2010-COA-452 (CAMA) AMENDED	INDIANAPOLIS HISTORIC PRESERVATION COMMISSION STAFF REPORT	Hearing Date MAR. 2, 2011
851-853 N. PARK AVE. CHATHAM ARCH - MASSACHUSETTS AVE.		Continued from: February 2, 2011 Jan. 5, 2011 November 3, 2010 Center Township Council District: 9 Jackie Nytes
Applicant TIMOTHY OCHS FOR PARK AVENUE mailing address: PROPERTIES, LLC One American Square, Suite 2900 Indianapolis, IN 46282		
Owner: Park Avenue Properties, LLC		
CASE		
IHPC COA: 2010-COA-452 (CAMA) AMENDED To replace 34 inappropriate vinyl windows installed without approval with 34 solid wood 3/1 replacement windows.		
STAFF RECOMMENDATION: Approval of a Certificate of Authorization

Owner’s Request - Amended

Certificate of Authorization/ Staff Analysis

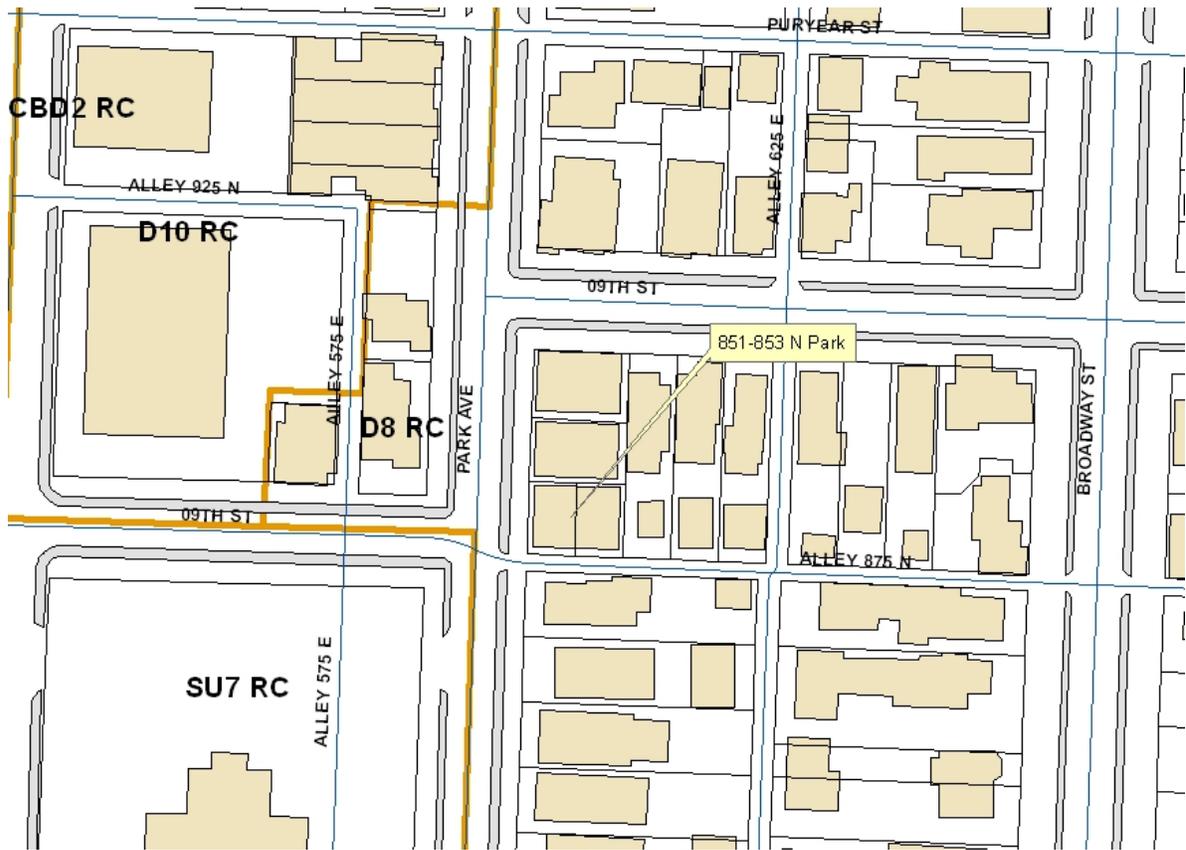
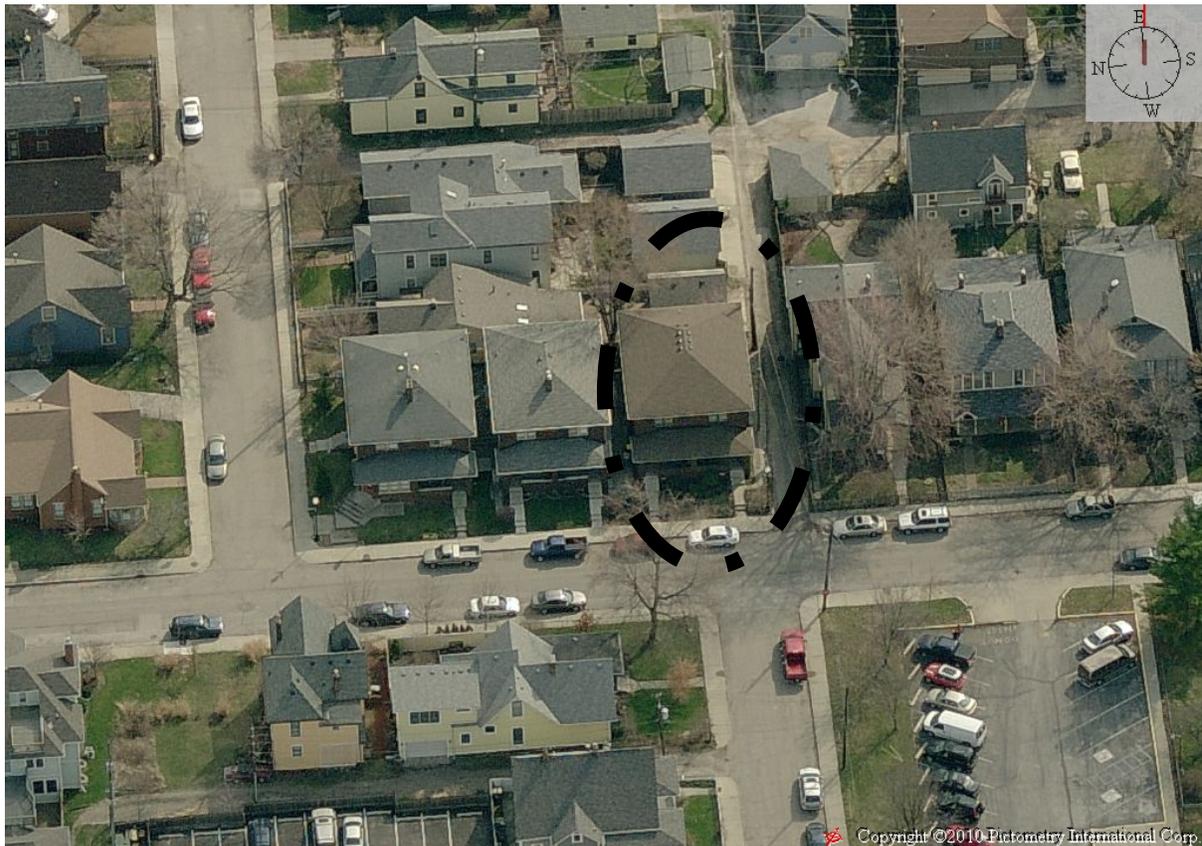
Staff finds the **retention of the existing windows** inappropriate for the following reasons:

1. The design guidelines in the Chatham Arch Massachusetts Avenue Preservation Plan (CAMA Plan) state that "*window replacement should be considered only when... the existing windows are not original and are not significant.*" All but four of the removed windows are believed to have been original and their design and configuration were significant to the architectural style of the building.

2. The replacement windows are inconsistent with the CAMA Plan criteria in the for replacement windows:
 - a. they are vinyl not solid wood, like the originals,

- b. Six of the replacements are 6-over-1 and do not replicate the original 3-over-1 pattern,
 - c. The muntins (both the 6-over1 and 3-over-1) sandwiched inside the insulated glass, providing no exterior element and profile.

- d. The muntins are relatively flat in design, unlike the profile original muntins. The glass appears to be tinted, giving the muntins a greenish color that appears different from the color of the sash.

2. The installation and retention of these vinyl sashes has a substantially negative effect on the historic character of this house and on its surrounding area because one of the most important visual characteristics of this double is its visual similarity to its two neighbors to the north, both of which still have their original and/or appropriate matching wood replacement windows. The vinyl windows installed on this double disturbs and diminishes that characteristic, significantly harming the character of the "grouping" and diminishing the historic character of this house.

To approve a Certificate of Authorization to install 34 solid wood 3-over-1 replacement windows in order to resolve a violation caused by unauthorized removal of original windows and unauthorized replacement with inappropriate vinyl windows. All per submitted documentation and subject to the following stipulations:

NOTE 1: The vinyl sashes must be removed and appropriate wood sashes installed no later than April 6, 2011.
